December 12, 2014

Subj: Amendment to Transfer Cottonwood Creek Canyon Wells from the Deer Creek Mine Monitoring to the Trail Mountain Mine Water Monitoring Program, PacifiCorp, Deer Creek Mine C/015/0018, Trail Mountain Mine C/015/0009, Emery County, Utah.

Title: Amendment to Transfer Cottonwood Creek Canyon Wells from the Deer Creek Mine Monitoring to the Trail Mountain Mine Water Monitoring Program, PacifiCorp, Deer Creek Mine C/015/0018, Trail Mountain Mine C/015/0009, Emery County, Utah.

Volume 1: Map HM-1A

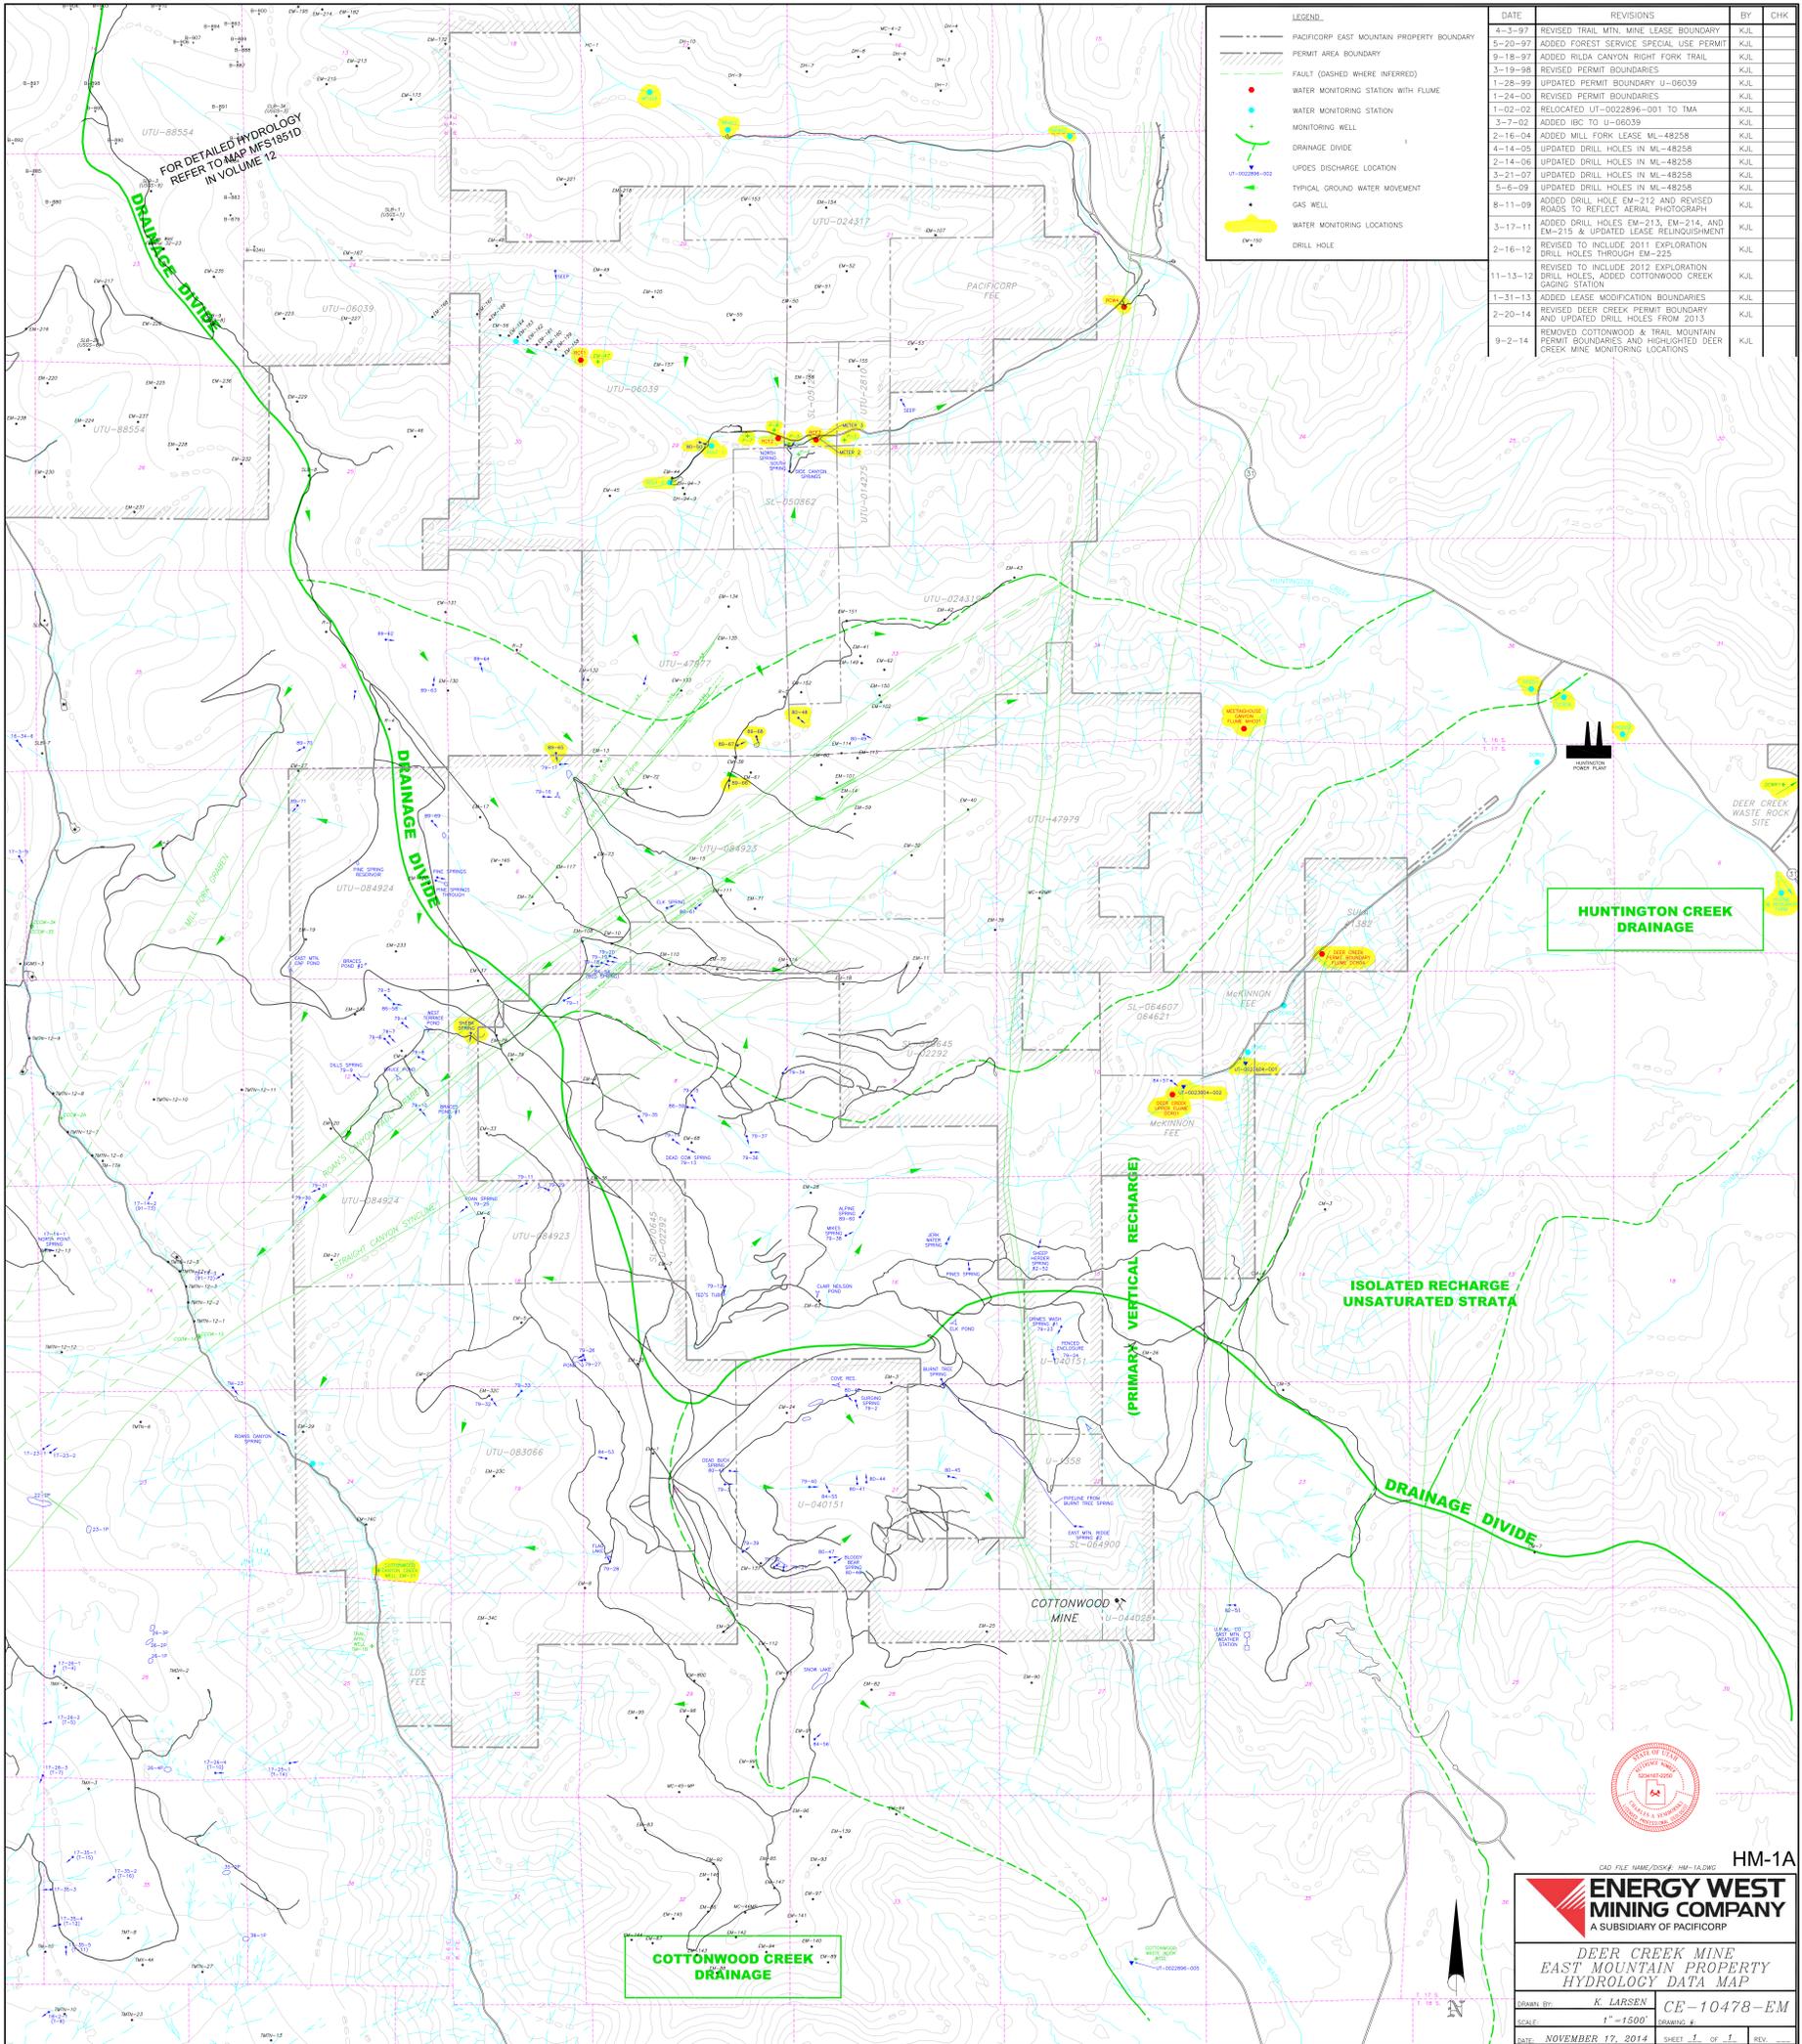
- Volume 1: Page 2-223 – Remove CCCW-1A, CCCW-1S, CCCW-2A, CCCW-3A, CCCW-3S U, and CCCW-3S L
- Volume 1: After page 2-225 - Remove CCCW-1A, CCCW-1S, CCCW-2A, CCCW-3A, CCCW-3S U, and CCCW-3S L from map HM-1A
- Volume 9: Appendix A-1 – Remove CCCW-1A, CCCW-1S, CCCW-2A, CCCW-3A, CCCW-3S U, and CCCW-3S L from Water Monitoring Program
- Volume 9: Maps Section – Remove CCCW-1A, CCCW-1S, CCCW-2A, CCCW-3A, CCCW-3S U, and CCCW-3S L from map HM-1A

Replace HM-1A

HM-1A

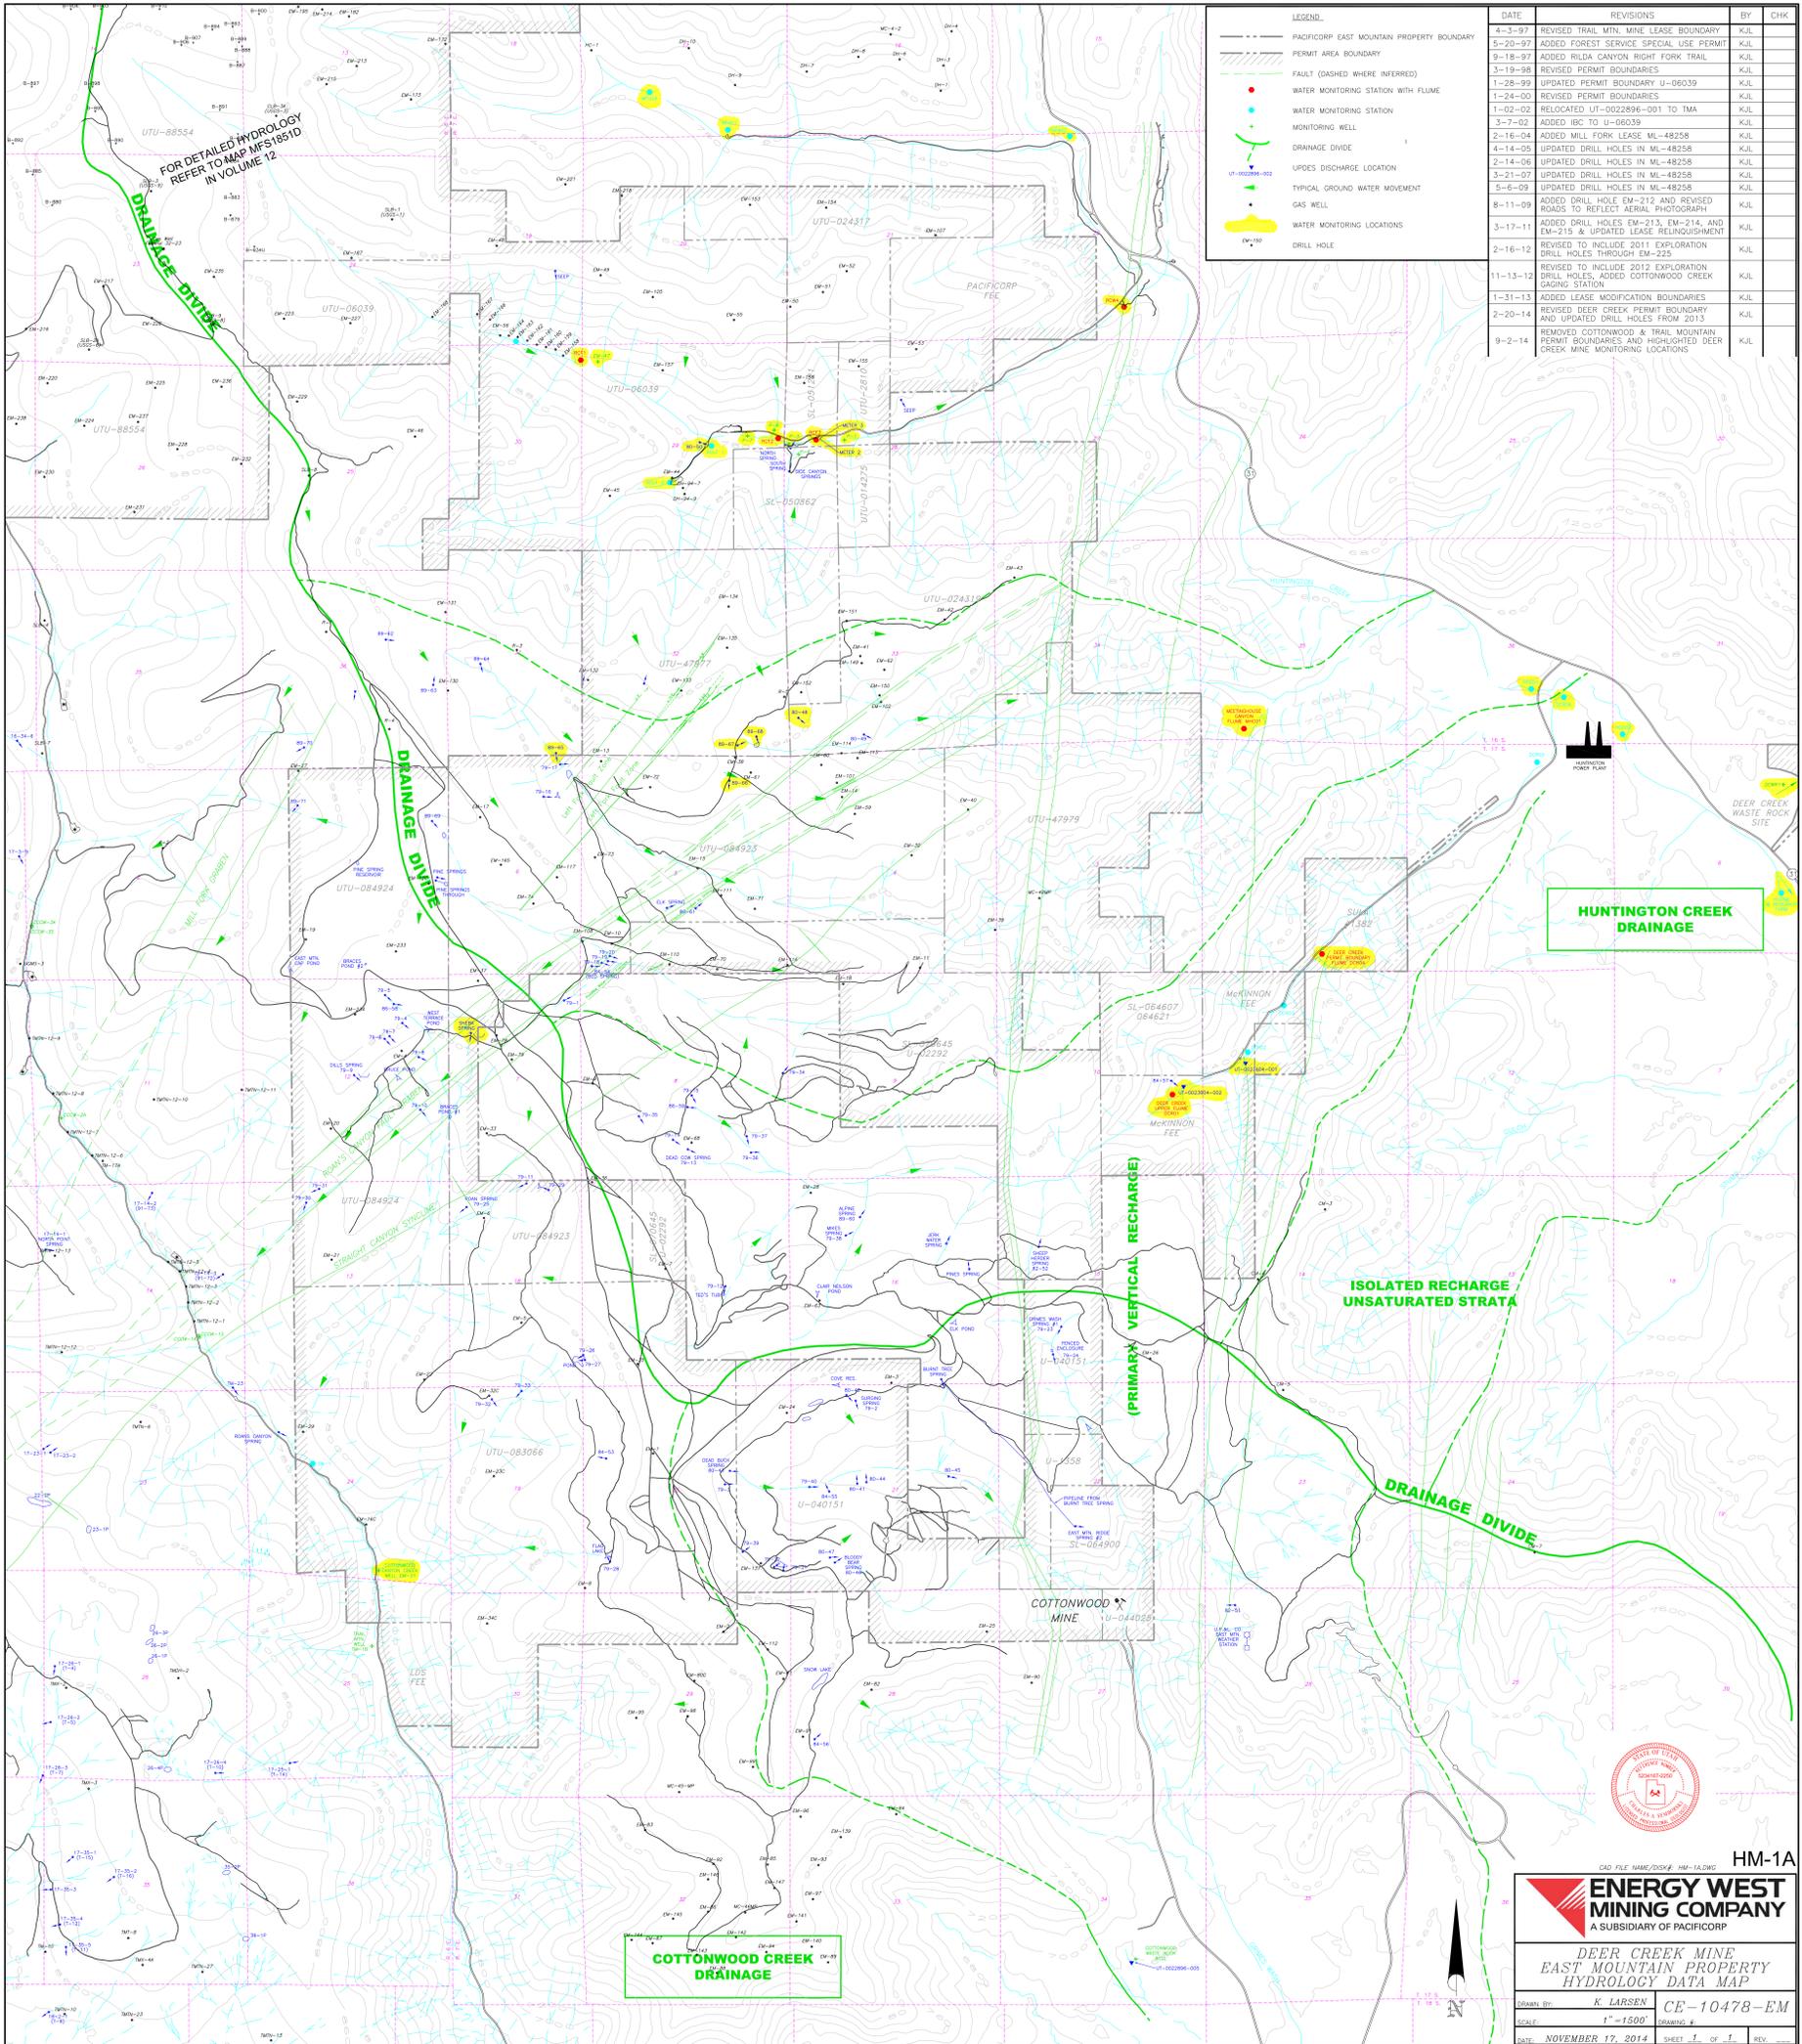
Appendix Volume: Appendix 7-1 – Add the location of monitoring wells CCCW-1A, CCCW-1S, CCCW-2A, CCCW-3A, CCCW-3S U, and CCCW-3S L to the Trail Mountain Water Monitoring Location Map.

Replace HM-1A

Replace Water Monitoring Program Table

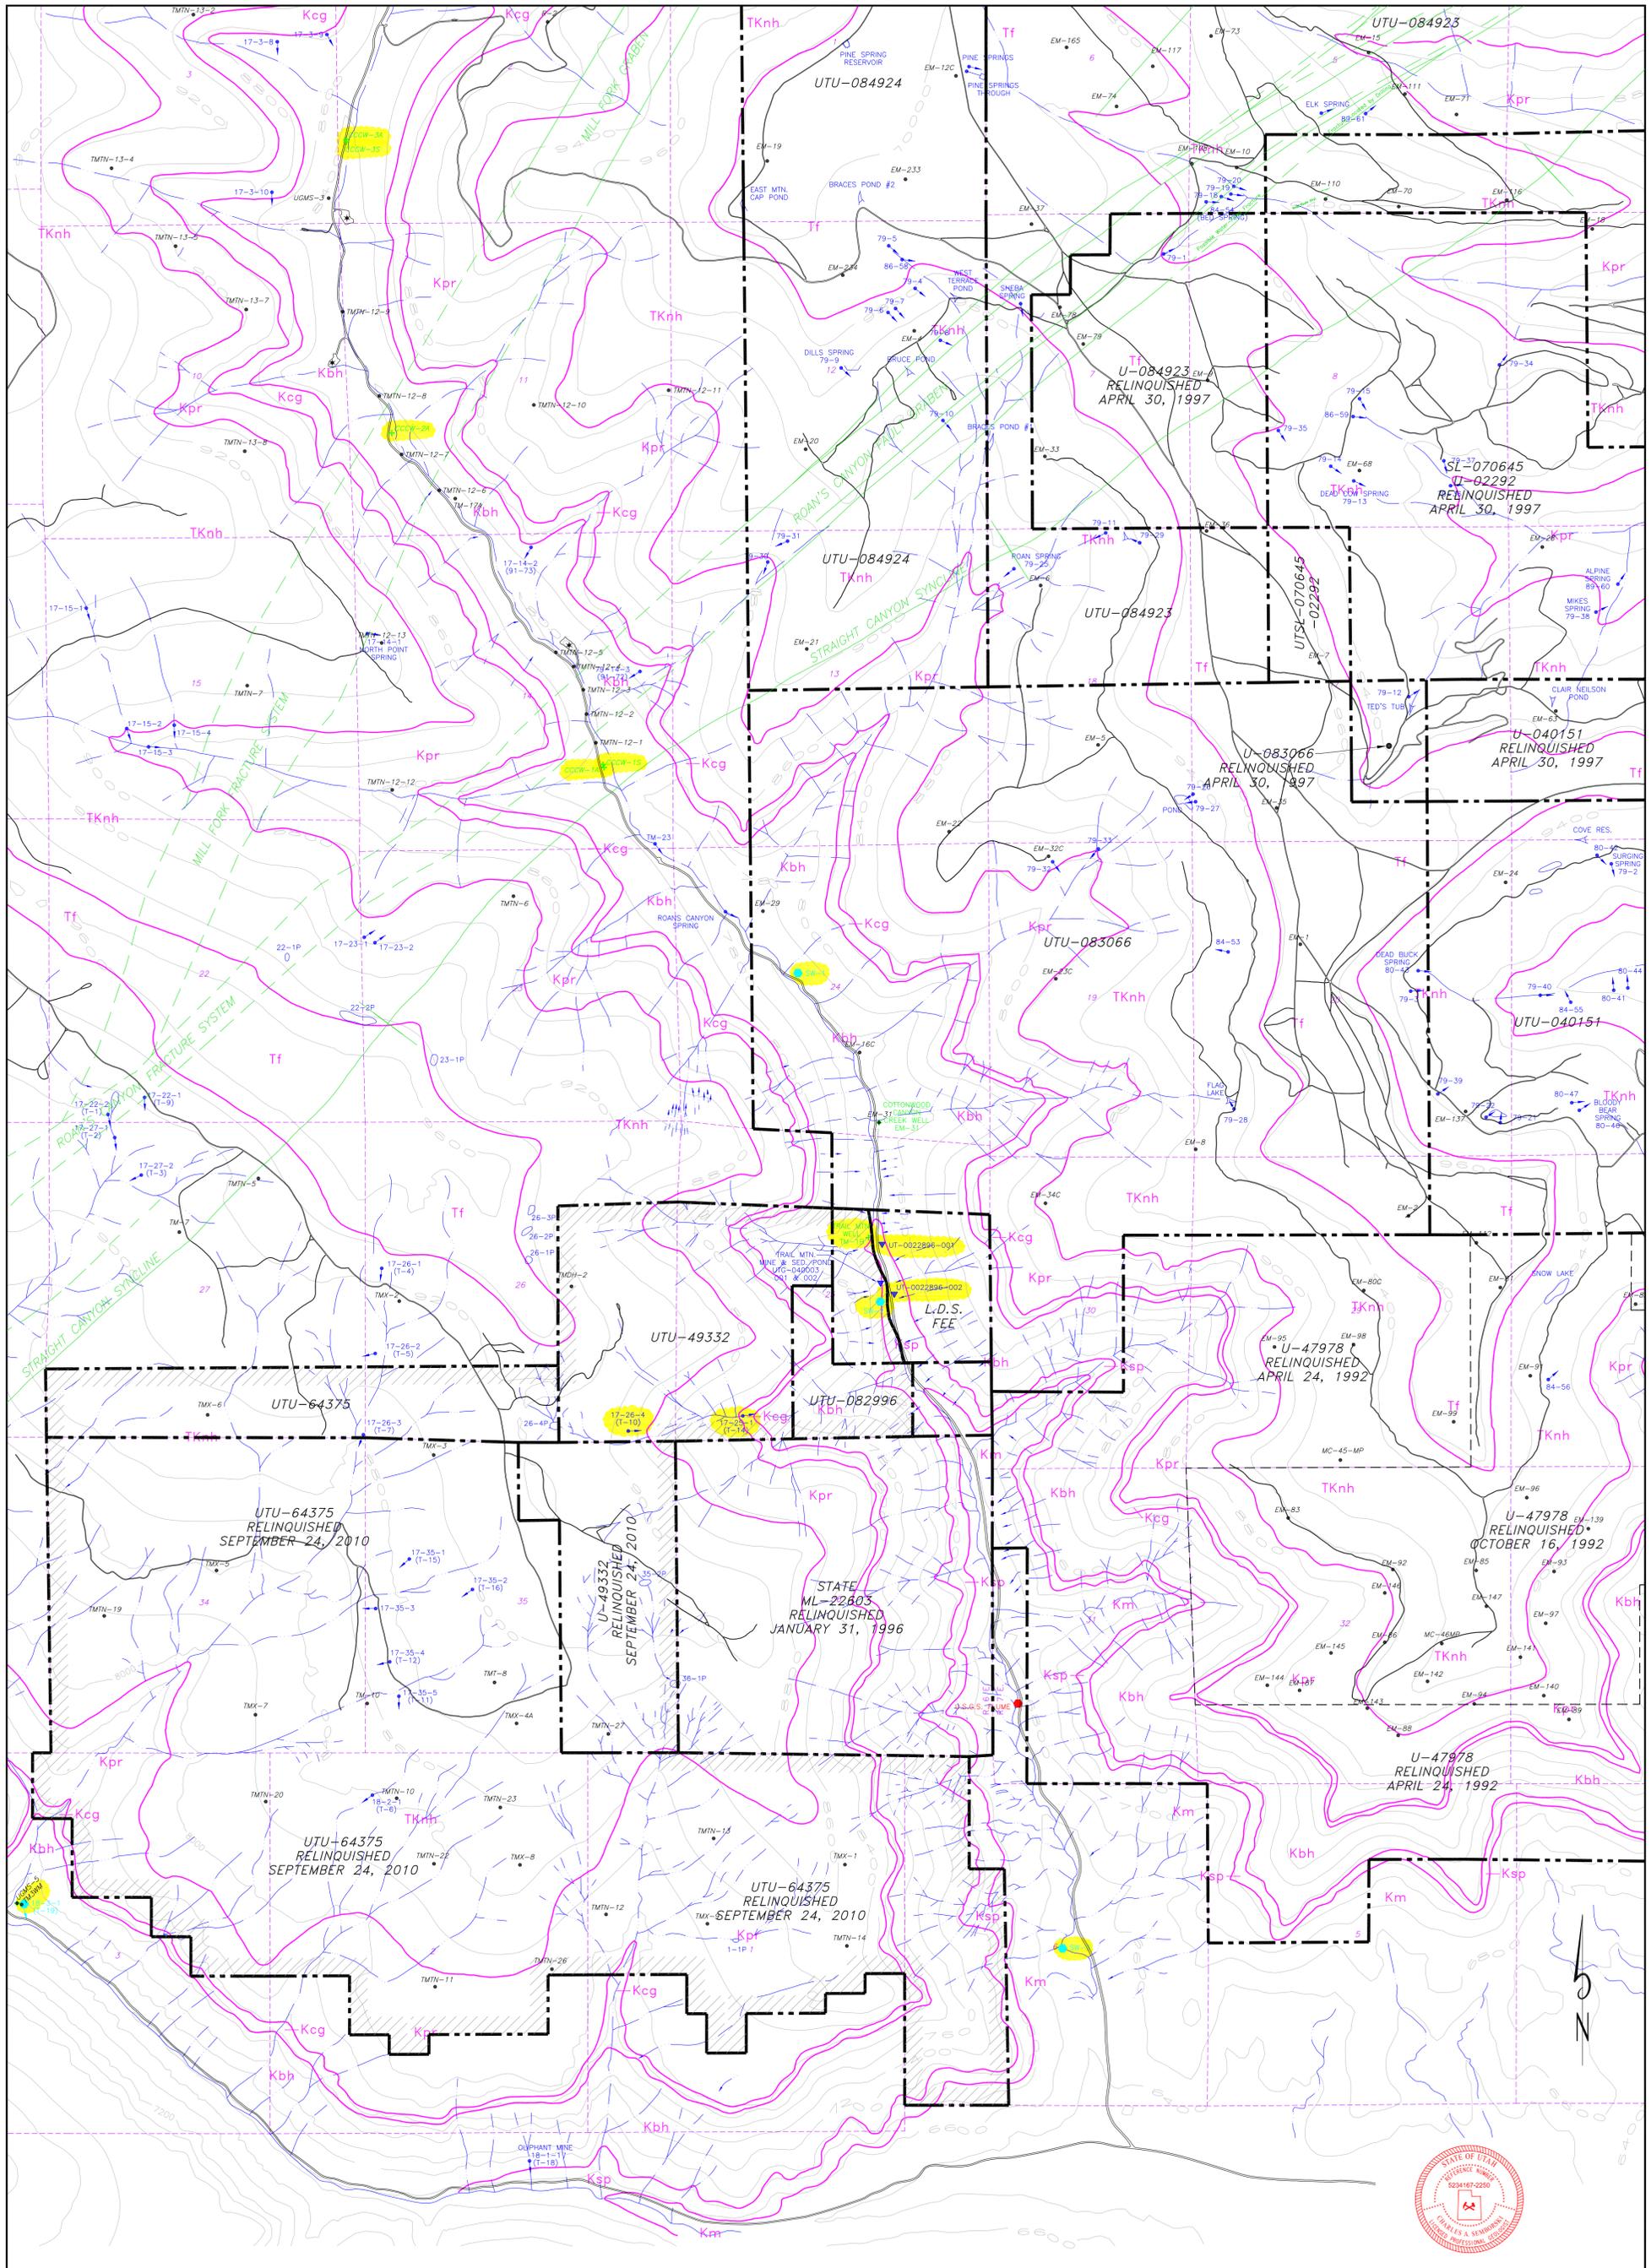
Appendix Volume: Appendix 7-1 – Add monitoring wells CCCW-1A, CCCW-1S, CCCW-2A, CCCW-3A, CCCW-3S U, and CCCW-3S L to the water monitoring program table.
